Los Angeles River Ecosystem Restoration Feasibility Study

**DRAFT – APPENDIX I
VALUE ENGINEERING STUDY**

VALUE ENGINEERING STUDY SUMMARY REPORT

DOD SERVICE: USACE
CONTROL NO: CESPL-13-02
VALUE ENGINEERING OFFICER: Arnecia Williams, AVS

Concrete planter cross-section

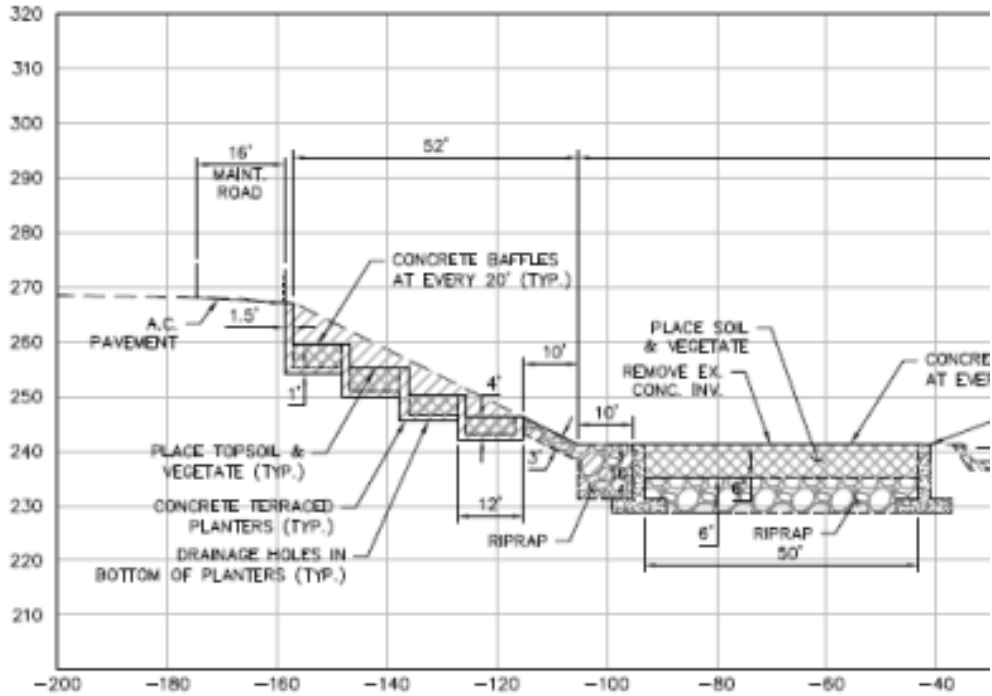
DESCRIPTION: Use Pre-Cast Concrete Planters and/or Modularize Planters

The original design utilizes 158,794 cubic yards of concrete planters which would be cast on site. Planters are integrated as ecosystem restoration features through use of riparian vegetation to provide edge habitat adjacent to the river.

The Proposed design is to incorporate either individual or modular pre-cast concrete planters in lieu of custom-fit planters cast at the site.

Using modular pre-cast concrete planters will reduce the cost of using custom planters while maintaining functionality. Using precast concrete planters provide for a quicker turnaround. It allows for the ability to begin casting components for the superstructure while foundation work is in progress. Precast concrete components can also be cast and erected year-round, without delays caused by harsh weather. Additionally, the new systems have a variety of textures, colors, finishes and inset options that can be used.

Examples of terraces with existing and proposed conditions. Proposed condition 1 will maximize the vegetation on the terraces and proposed condition 2 allows for minimum vegetation.

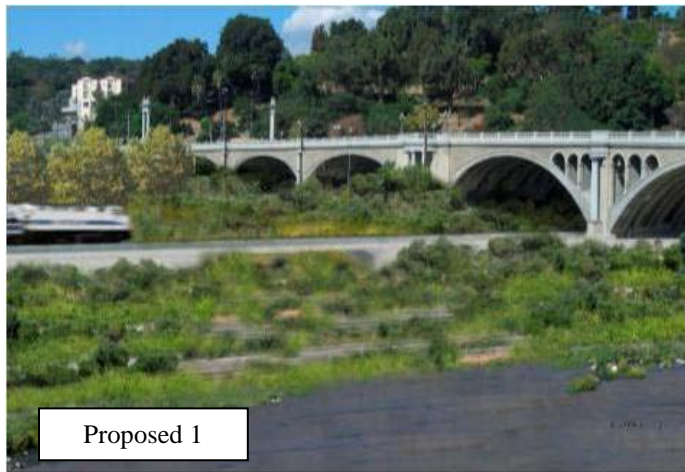
DESCRIPTION: Modify the Terraces

Terraces are incorporated throughout each reach to reduce the angularity of the trapezoidal channel, serve as a medium for vegetative restoration and provide public access points to the river. Terraces require demolition of the existing channel surface, change to the channel geometry and reconstruction through the use of concrete planters and surface walkways.

The proposed design is to reduce the scale of the terraces by 33% to achieve cost savings for the project.

Terraces compose a significant portion of the total project costs. Reduction in the scale of the terraces may be able to be achieved while maintaining high priority ecosystem restoration areas.

GRADE CONTROL STRUCTURE DETAIL

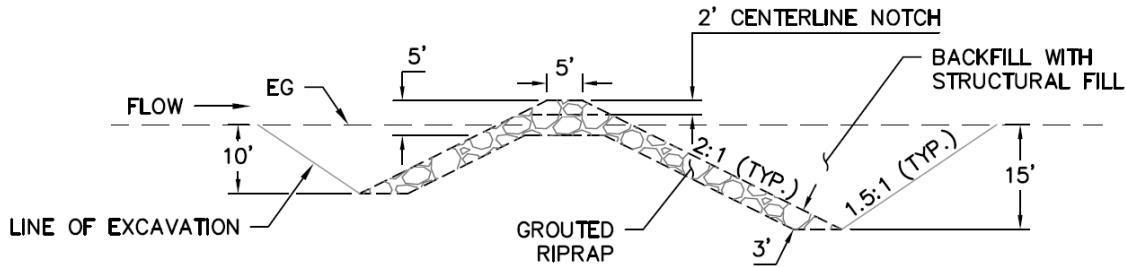
DESCRIPTION: Use Random Material for Grade Control Structures Cores

The original design calls for grouted rip-rap grade control structures with a compacted fill core.

The proposed design calls for a random fill core. From the available data the quantities and units costs were derived. A 25% reduction in the cost of the core fill was assumed.

Illustration Provided

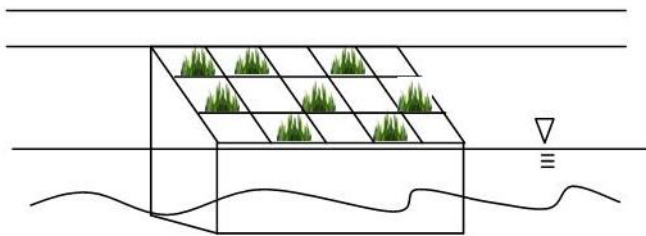
7. **Use Differently Armored Banks.** Instead of terraces at some places, or to replace grouted riprap slopes, or where geo-engineered banks are infeasible, use an armored bank that will allow vegetation to grow in gaps. This could be a concrete “egg carton” inset into the bank or box concrete storm culverts could be repurposed and inset vertically to create a structural slope with infill that is vegetated. This could present a significant cost saving to cast-in-place boxes while offering some habitat.

Illustration provided

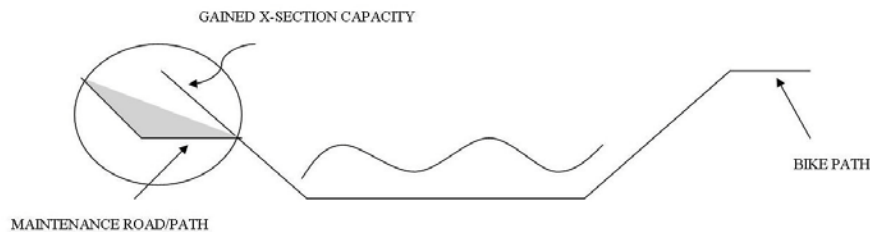
12. **Increase Capacity by Lowering Maintenance Roads.** In strategic places it may make sense to change the location of the maintenance roads and notch it into the channel (see illustration). This would be most beneficial where we know there is a chance of break-out during a rare rain event, or the maintenance part is wide enough at the top to still accommodate emergency access during rain even, or there would be little impact to existing structures at the top of the bank. The road should be placed at the level of storm event for optimized access (say 20% storm). The excess capacity could offset increase vegetation (roughness) elsewhere in the channel.

Cross-section examples of freshwater marsh areas

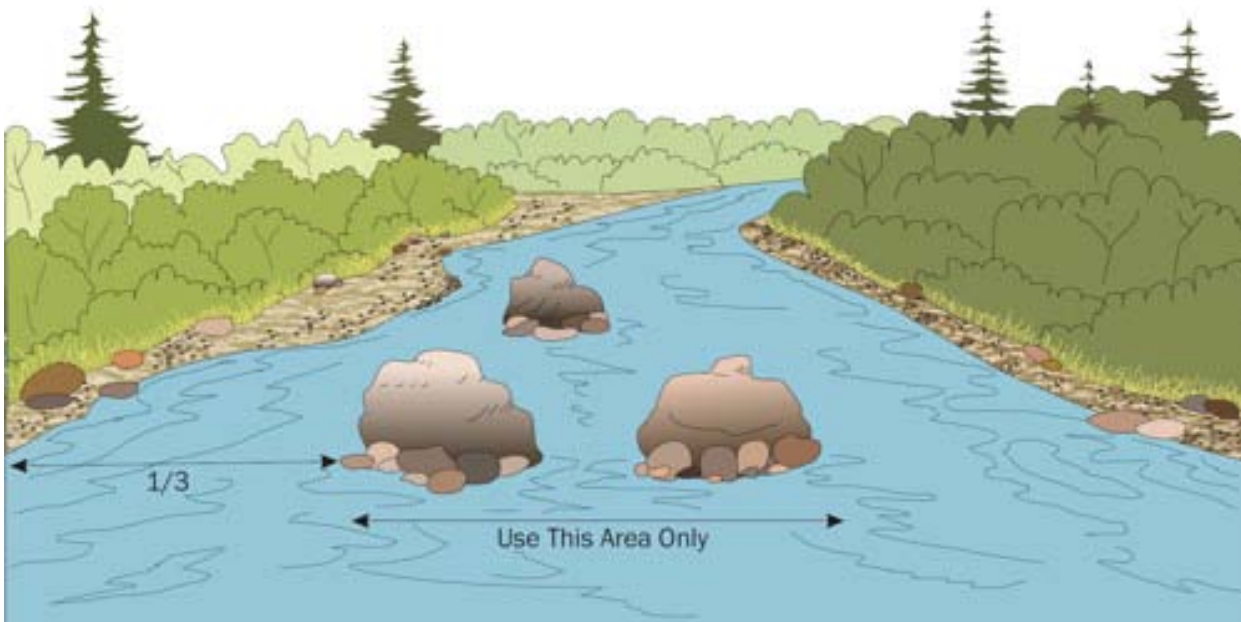
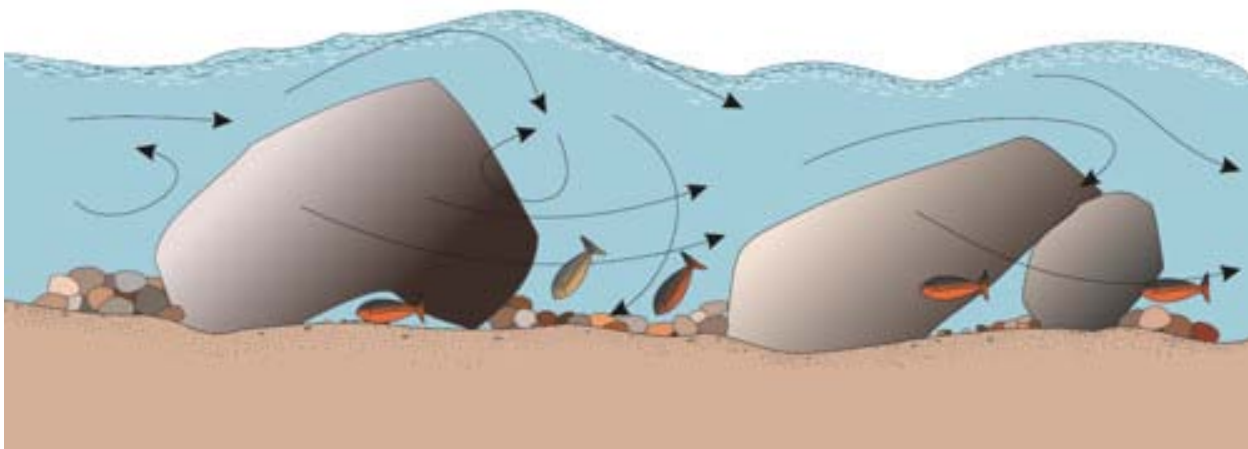
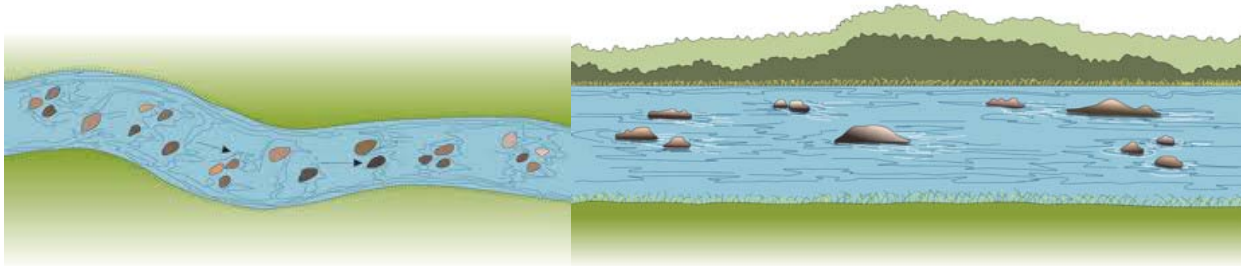
21. **Increase Channel Complexity.** The VE team suggested that the project increase the channel complexity. Some ideas are as follows:
Restore freshwater marsh areas at the confluence of the main stem of the LA River and tributaries such as Burbank Channel, Verdugo Wash and Arroyo Seco.
Incorporate boulder fields in bottom of channel through the marsh areas to provide in-stream habitat refuge and resting areas for aquatic species. Boulders provide velocity breaks during high flows to disperse energy and allow for refuge areas for aquatic species. Boulder fields may mobilize during high flows and will require evaluation. Integration of channel complexity into the marsh design will require consideration of maintenance for replacement of lost material. Addition of boulder fields will increase project benefits at minimal cost.
